Drawing Change Notice

CHANGE DOCUMENT NO.
24590-PTF-VDCN-MS-10-00009

JOB NO.	TITLE FOR CHANGE NOTICE
24590	UFP-VSL-00062C Redesign

Based on the re-analysis of UFP-VSL-00062C, per calculation 24590-PTF-MVC-UFP-00023, for revised seismic conditions and design evolution, required a redesign of the vessel.

VESSEL ELEVATION
SCALE: ⅜" = 1'-0"

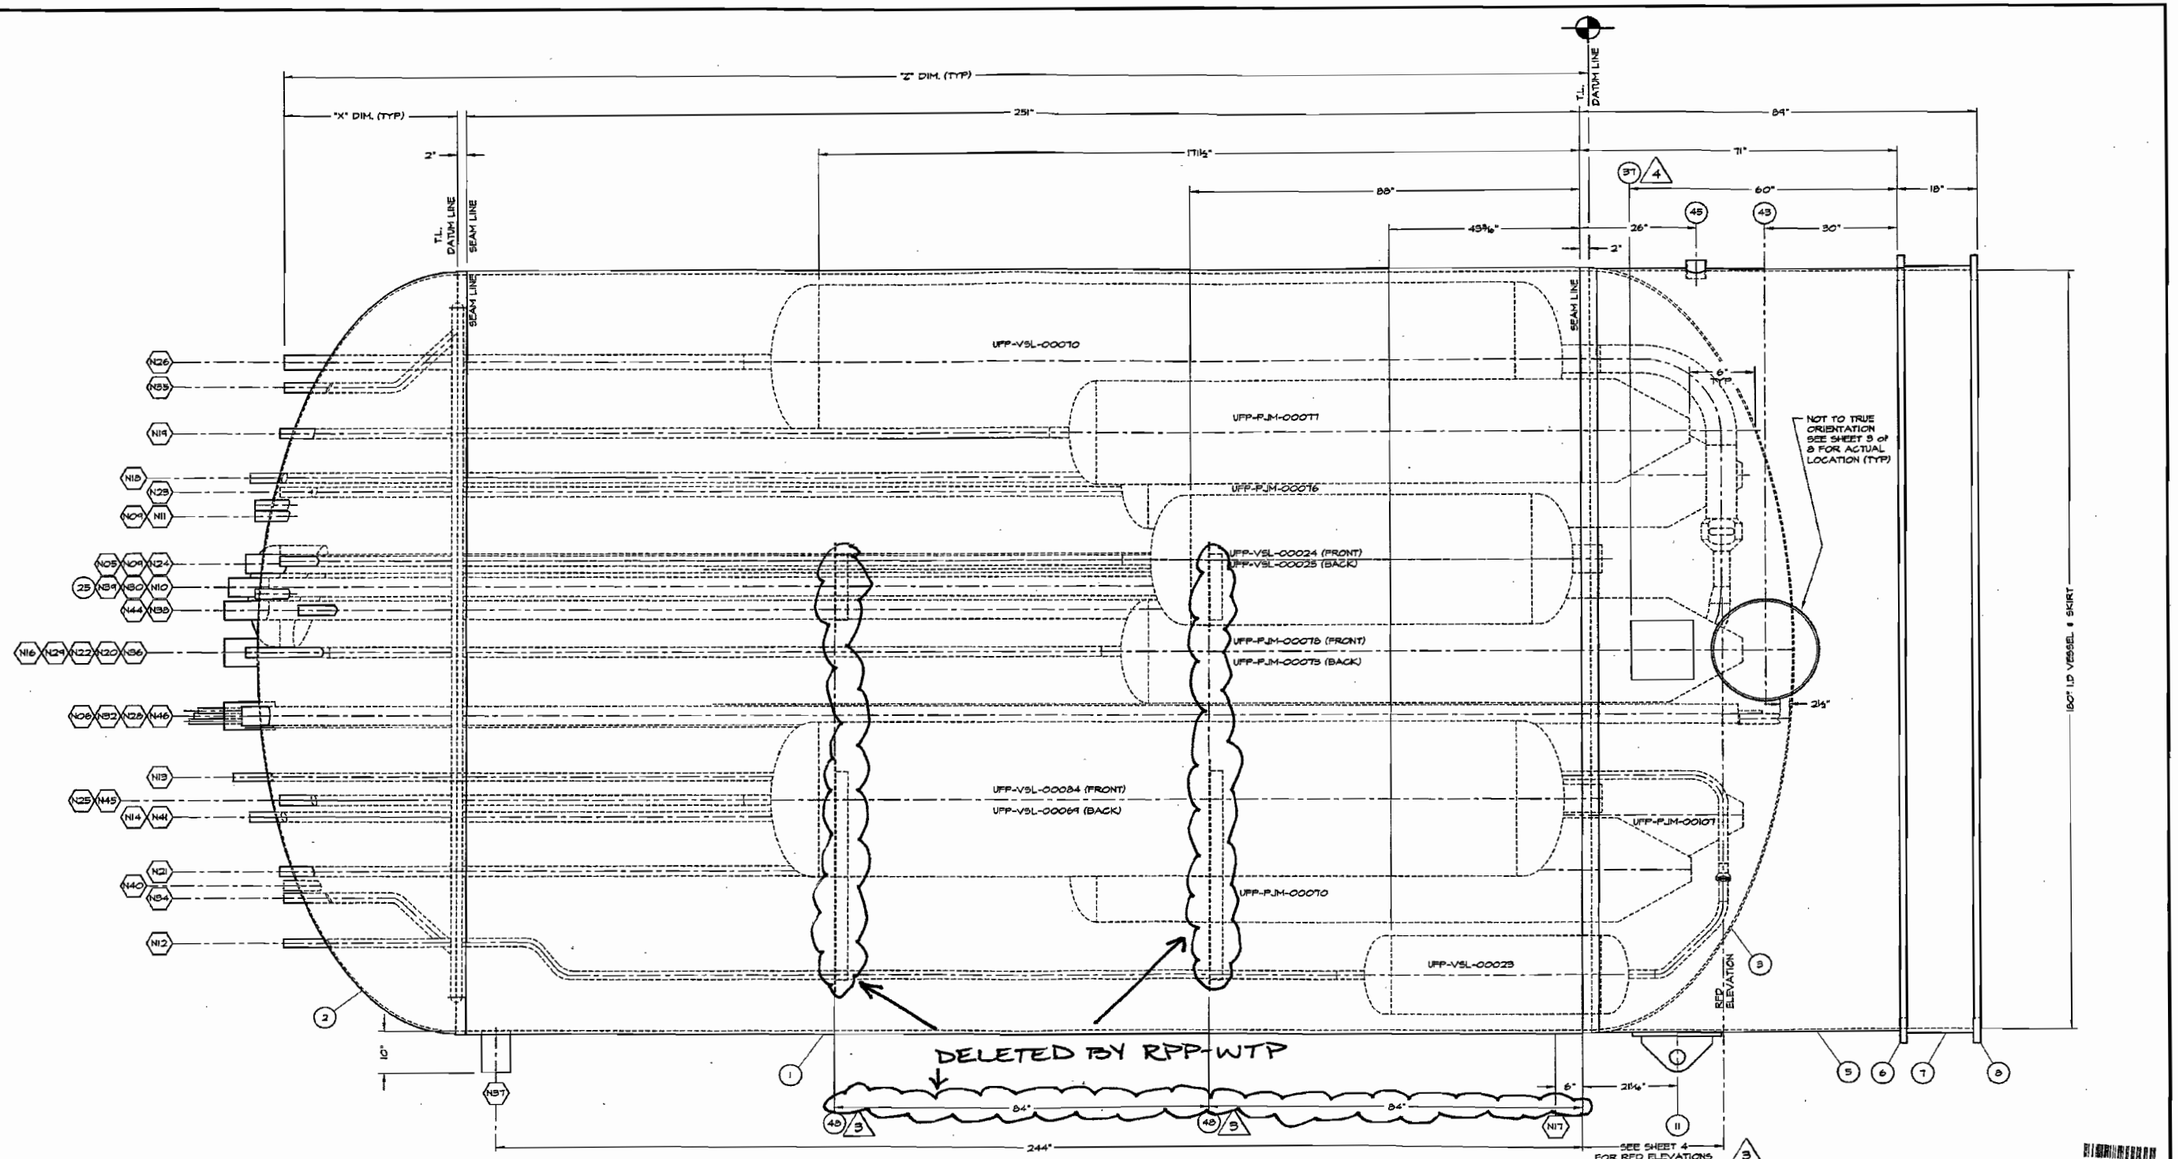
a.) Vessel Elevation View:

(1.) Delete supports and associated part bubbles depicted on drawing.

(2.) Delete support dimensions depicted on drawing.

VESSEL ORIENTATION
SCALE: 3/8" = 1'-0"

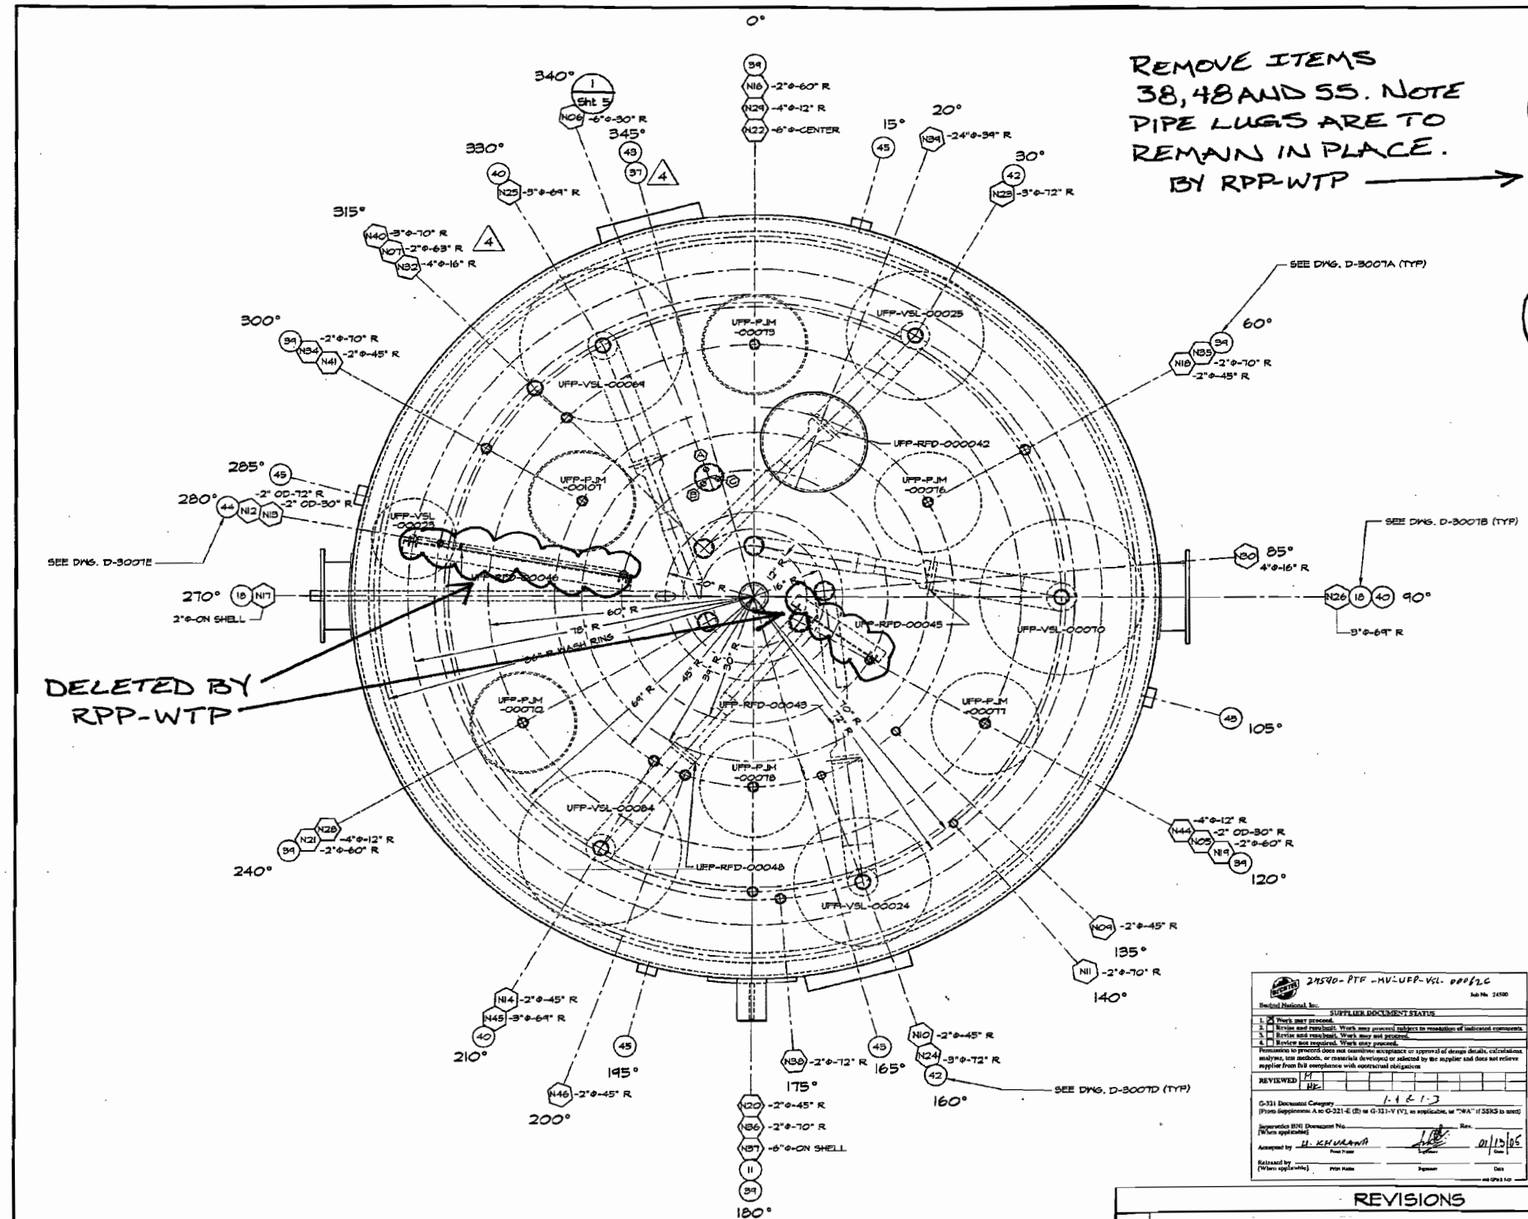
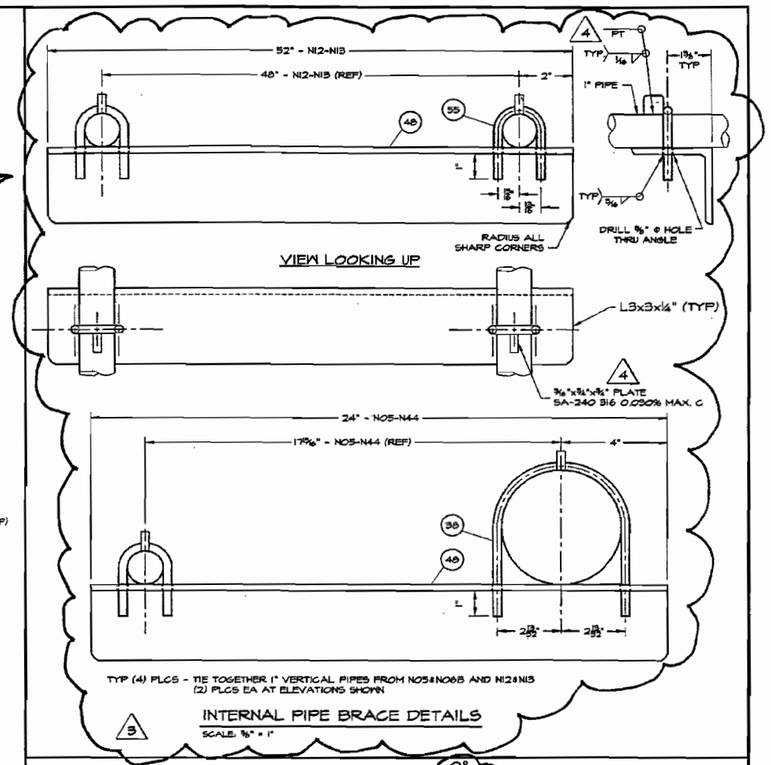
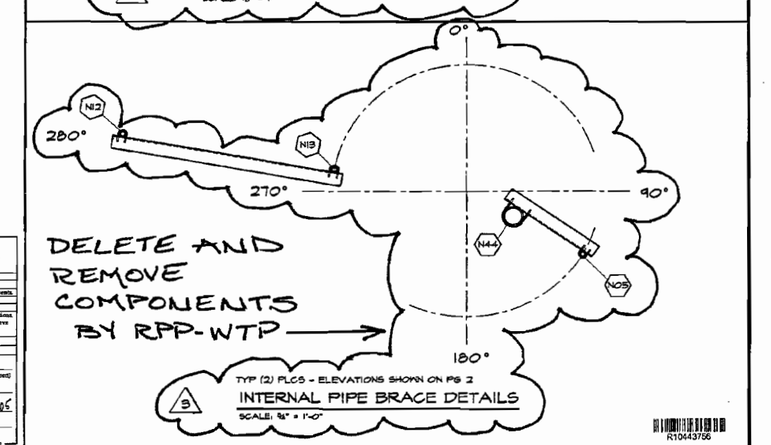
a.) Vessel Orientation: Delete supports as shown.

b.) Internal Pipe Brace Details: Remove items 38, 48 and 55. NOTE: Pipe Lugs are to remain in place.

c.) Internal Pipe Brace Details: Delete detail and remove components.

REMOVE ITEMS 38, 48 AND 55. NOTE PIPE LUGS ARE TO REMAIN IN PLACE. BY RPP-WTP

NORTH ELEVATION

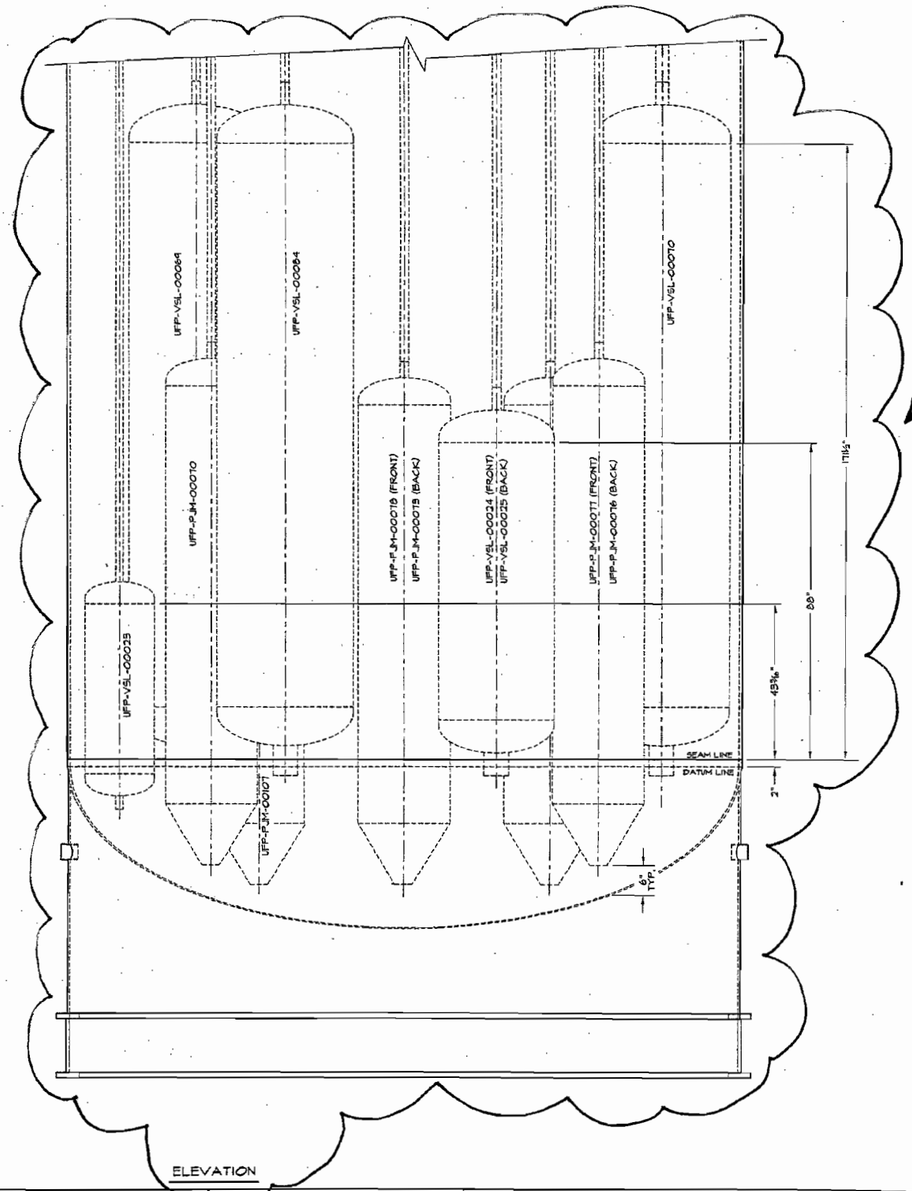
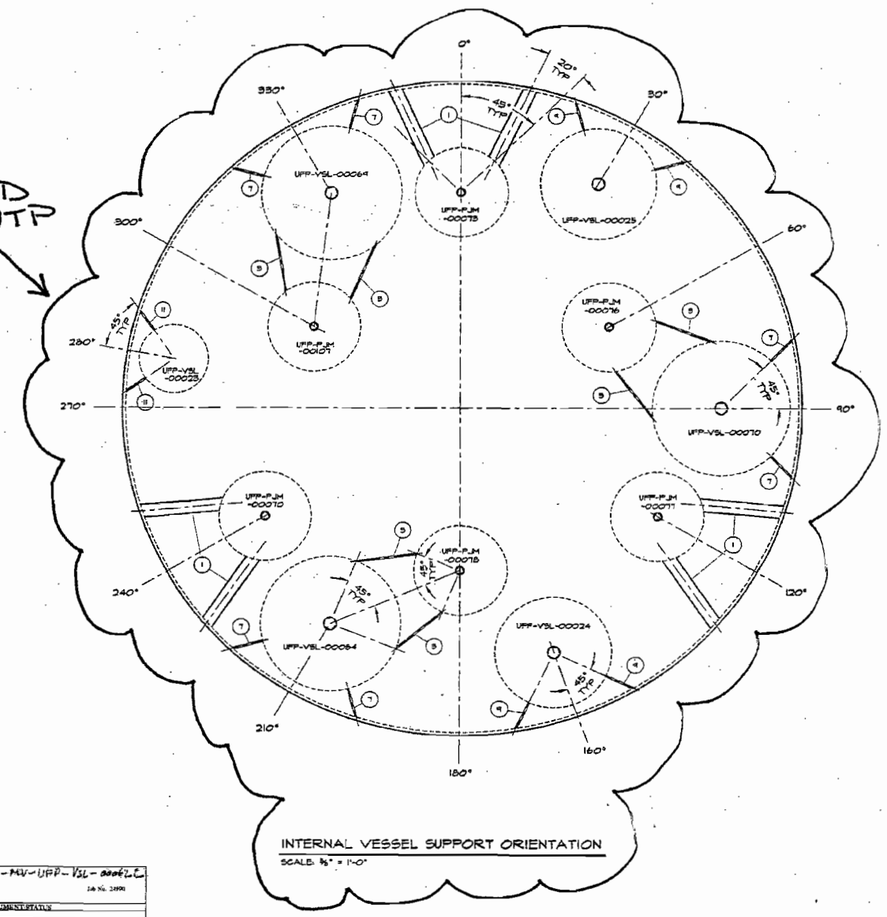
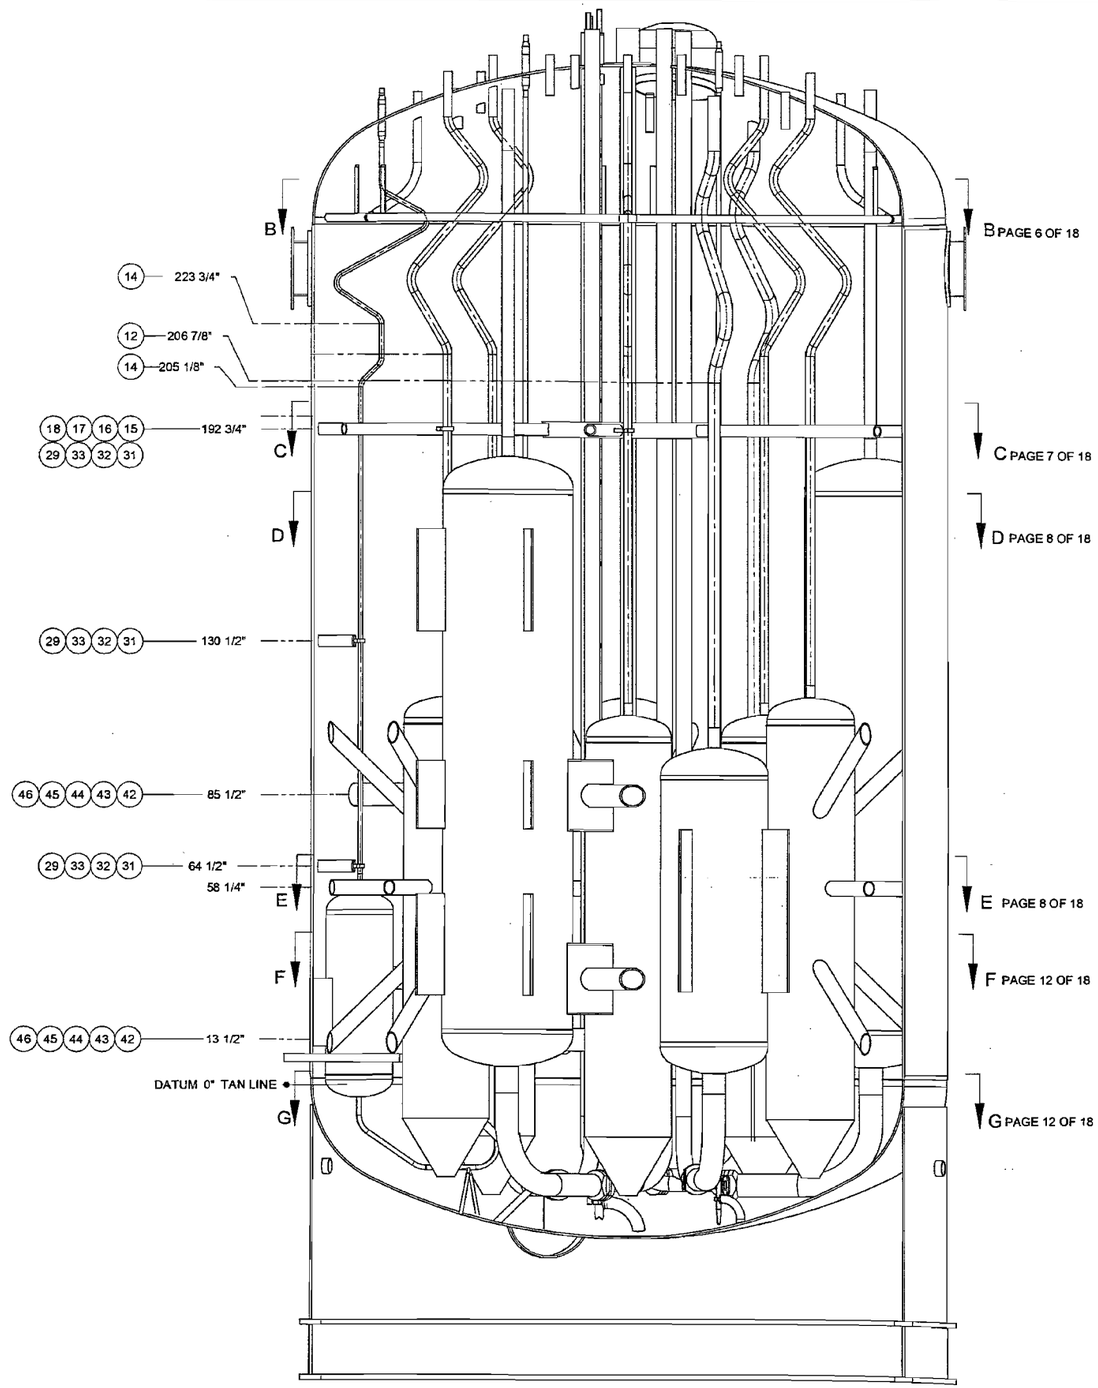
a.) Elevation View: Delete Elevation View and replace with NORTH ELEVATION VIEW shown on Attachment 1, page 5 of this VDCN.

b.) Internal Vessel Support Orientation: Remove view as this will be covered in Sections B-B, C-C, D-D, E-E, F-F, and G-G shown on Attachment 1, page 5 of this VDCN.

ELEVATION

DELETED BY RPP-WTP

SECTION B-B
SCALE: 1/16

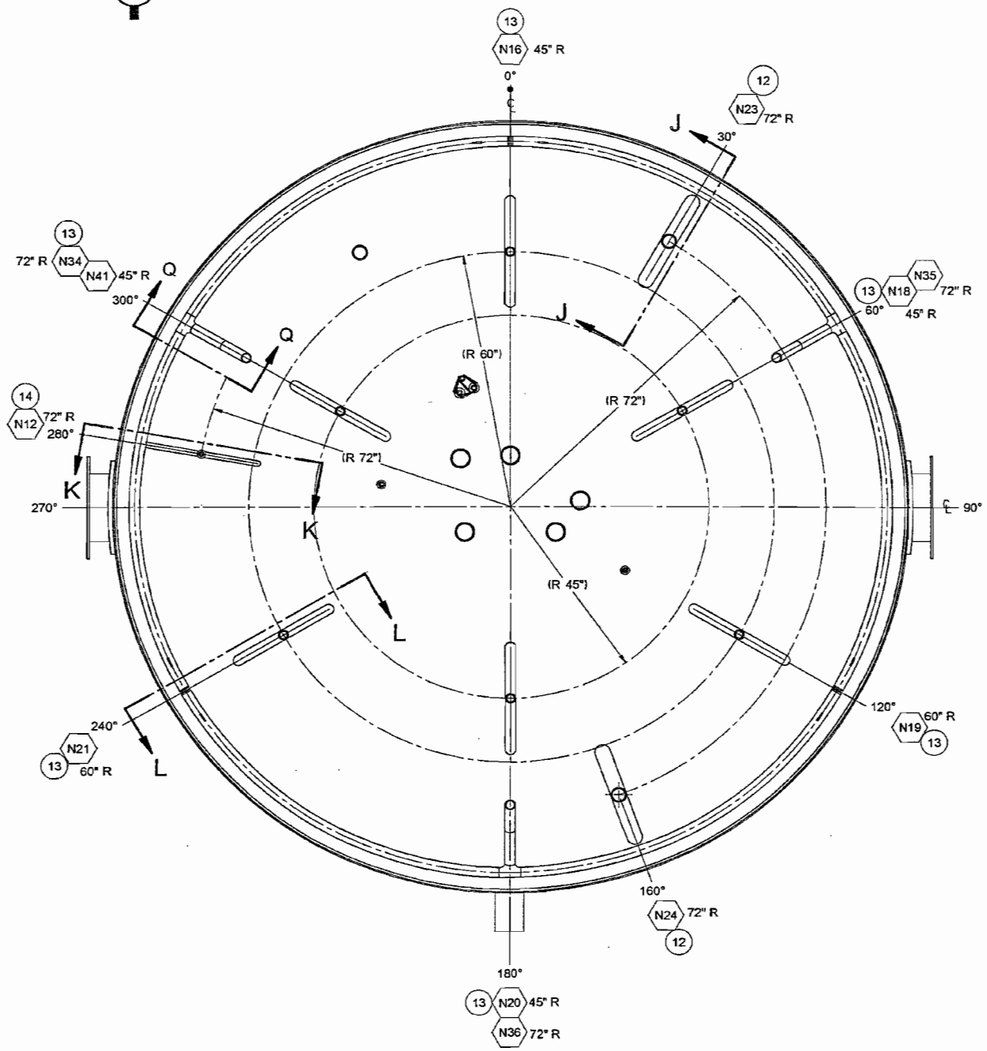
d.) Add SECTION B-B shown on Attachment 1, page 6 of this VDCN.

12 SECTION J-J
THERMAL EXPANSION S-BEND
SCALE: 1/10

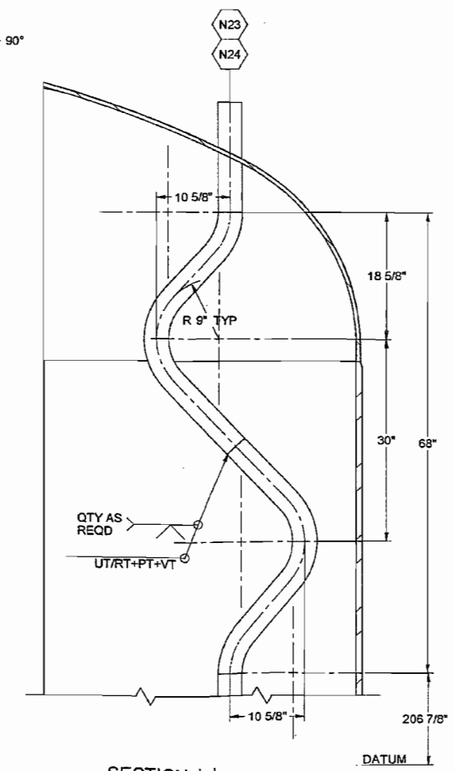
e.) Add SECTION J-J and item 12 THERMAL EXPANSION S-BEND shown on Attachment 1, page 6 of this VDCN.

14 SECTION K-K
THERMAL EXPANSION S-BEND
SCALE: 1/10

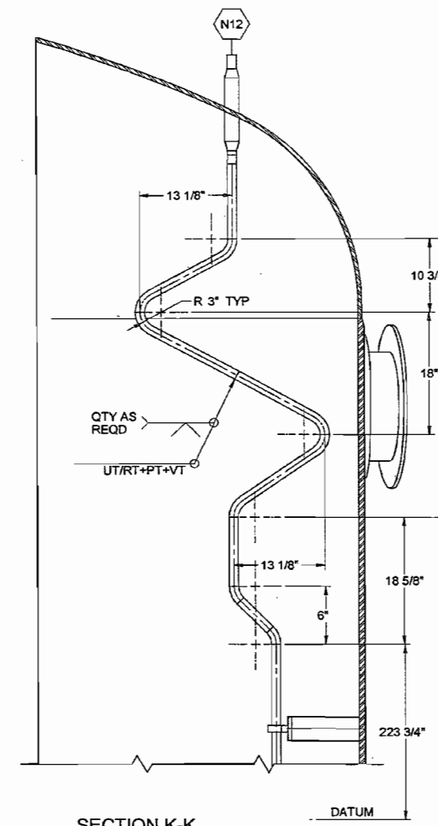
g.) Add SECTION K-K and item 14 THERMAL EXPANSION S-BEND shown on Attachment 1, page 6 of this VDCN.

SECTION Q-Q
SCALE: 1/10

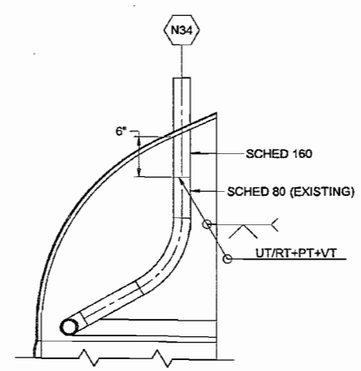
a.) 2"SCH 80 INLET TO INTERNALS: Delete N34 and replace with Typical SCH 160 Nozzle Detail (REF Section Q-Q, Attachment 1, page 6 of 18).

a.) WASH RING TEE: Delete N34 and add Section Q-Q which depicts N34 details show on Attachment 1, page 6 of this VDCN.

13 SECTION L-L
THERMAL EXPANSION S-BEND
SCALE: 1/10

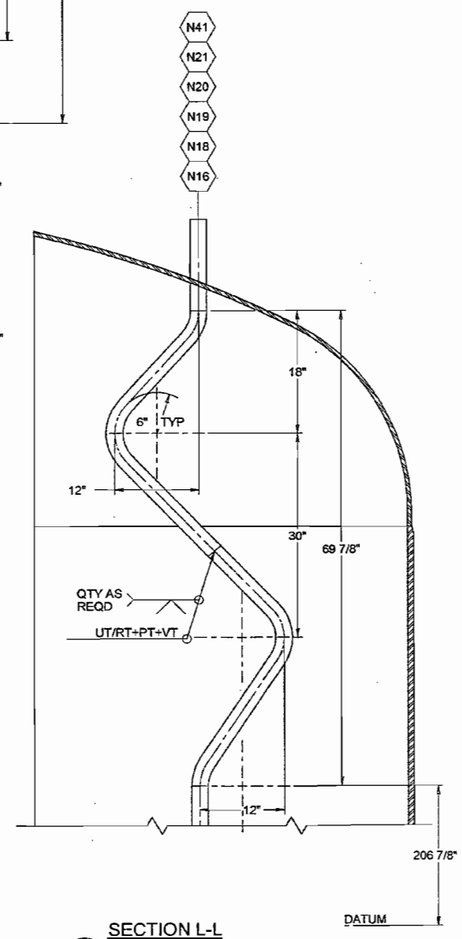
f.) Add SECTION L-L and item 13 THERMAL EXPANSION S-BEND shown on Attachment 1, page 6 of this VDCN.
